Re: Turkey Point Units 3 and 4
Docket Nos. 50-250 and 50-251
Request for Additional Information Regarding
Station Blackout Analysis (TAC Nos. MB8728 and MB8729)

**Response To NRC Request for Additional Information
Regarding Station Blackout Analysis for
Turkey Point Units 3 and 4**

FIGURE 1

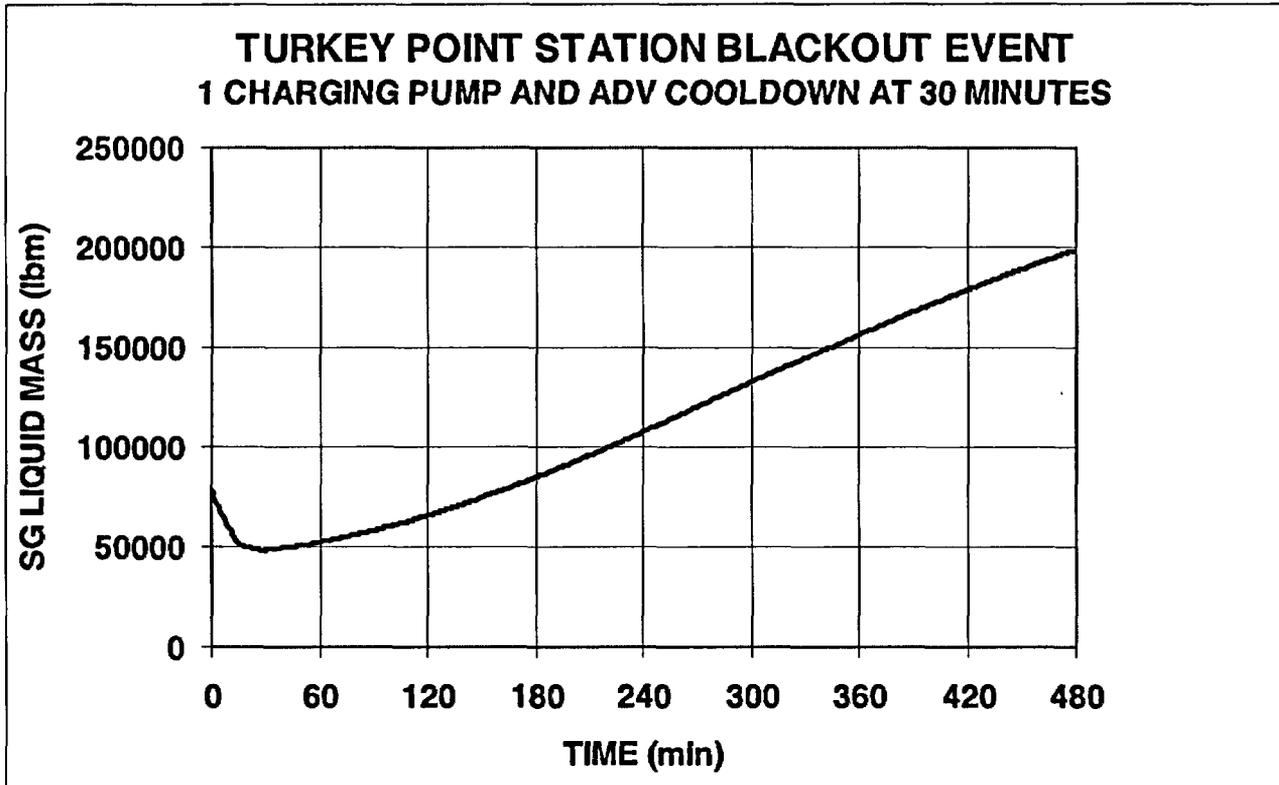
- A single volume is used for the upper head. Because an equilibrium model was employed, this region fills completely at 375 minutes, which does not appear to be correct. Once the SGs refill with liquid and single phase natural circulation is re-established, a bubble will remain in the upper head region (unless the RCPs are re-started or the head vent is used). Thus, following refill, the upper head will become superheated with wall heat transfer from the steam controlling the degree of steam superheat. The use of the single volume to represent the upper head and the equilibrium model will artificially condense the steam in this region, enabling a complete and early refill. Discuss whether a bubble in the upper head will significantly delay the ability to cool down the RCS to RHR entry conditions within the 8-hour period. A bubble in the upper head would cause the pressurizer level to decrease during charging pump operations. Given these considerations, discuss whether entry into shutdown cooling will be achieved before the condensate storage tank is exhausted. Discuss whether entry into shutdown cooling will be delayed if a fill-and-drain method is used and metal wall heat is taken into account. Include the capacity of the condensate storage tank and identify the time to exhaust this supply during the cooldown.*

Allowing phase separation in the region and modeling it as a non-equilibrium volume with metal heat from the vessel and structures would provide a more accurate response of the dynamics of the region. In particular, heat transfer from the metal to both the liquid and vapor phases would be predicted along with condensation of vapor onto the interface. This would have an effect on the depressurization rate and the time of refilling the region. However, given the fact that the heat sink is maintained through the continuous addition of auxiliary feedwater for the duration of the 8-hour event, this effect is not expected to challenge the overall conclusions of the analysis in terms of potential core uncover.

Each unit's Condensate Storage Tank (CST) contains sufficient inventory to maintain the unit at hot standby for 15 hours and then cooled down to below 350 °F in 4 hours. With this requirement and the conditions of the SBO scenario analyzed herein, it is unlikely that the CSTs would have been depleted during the 8 hour duration of the SBO event.

Given the relatively small RCS cooldown rate of 25 °F/hr, intended to prevent excessive upper head voiding, the homogeneous representation of the vessel upper head in the RETRAN model is considered appropriate for this application.

Aspects related to the capability to collapse the vessel upper head bubble, if still present at 8 hours when the shutdown cooling phase starts, are beyond the assumptions of the SBO analysis because at the end of the 8-hour period, the SBO event is assumed to terminate. The RETRAN analysis concluded that during the 8-hour SBO period, the aspects related to the dynamics of the upper head bubble will not interfere with the ability to maintain the core cooled, provided the heat sink is maintained, as demonstrated above.
